# DEVELOPMENT REVIEW BOARD REPORT

**Hudson East**  
**8-DR-2018**

**Request:** Request approval of the site plan, landscape plan, and building elevations for a new two-story multi-family condominium development consisting of 18 dwelling units in four buildings, with approximately 40,400 square feet of building area, all on a 1.27-acre site.

Left Elevation (McDonald Drive)

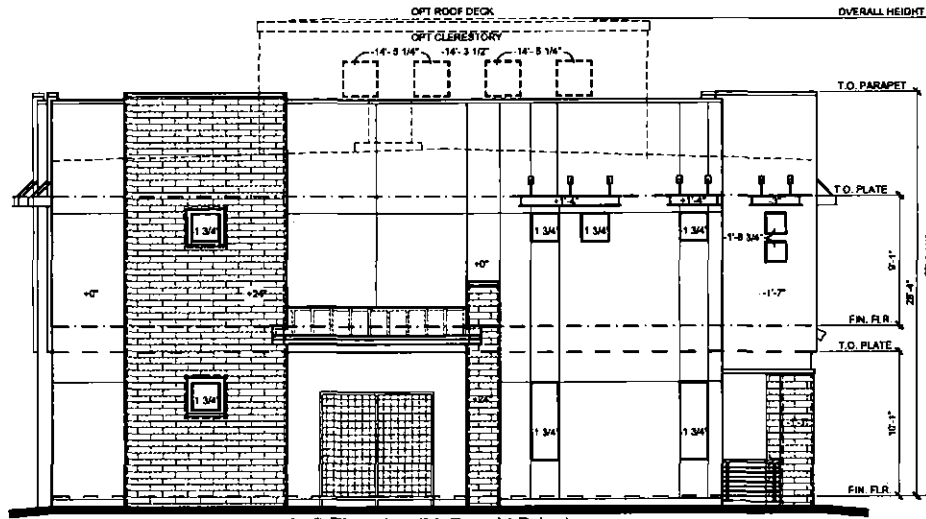
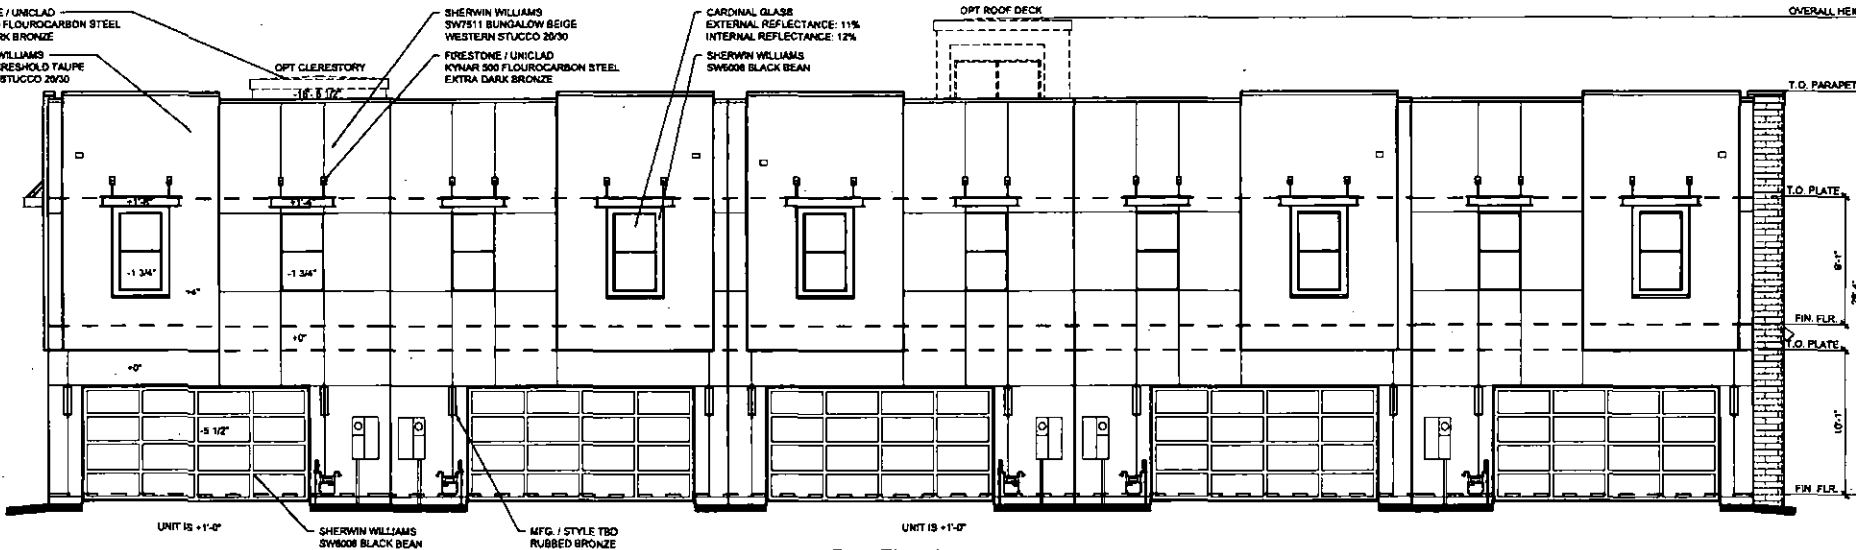
- The building massing along the McDonald Drive frontage did not appear appropriate to the project.
  - Consider incorporating a standing seam metal shed type roof, similar to other buildings in the area, to possibly bring the scale down along the street frontage.
  - Consider incorporating balcony elements facing McDonald Drive to break up the massing.
  - Consider utilizing the zoning ordinance's allowed projections into the required front yard to break up the massing.
  - Consider landscape alternatives to soften the visual impact.
- The exterior colors did not appear to provide enough contrast.
  - Consider more distinction between the stone and the body colors.

Staff has reviewed the applicant's revised design proposal and believe that the Board's comments have been taken into account and addressed.
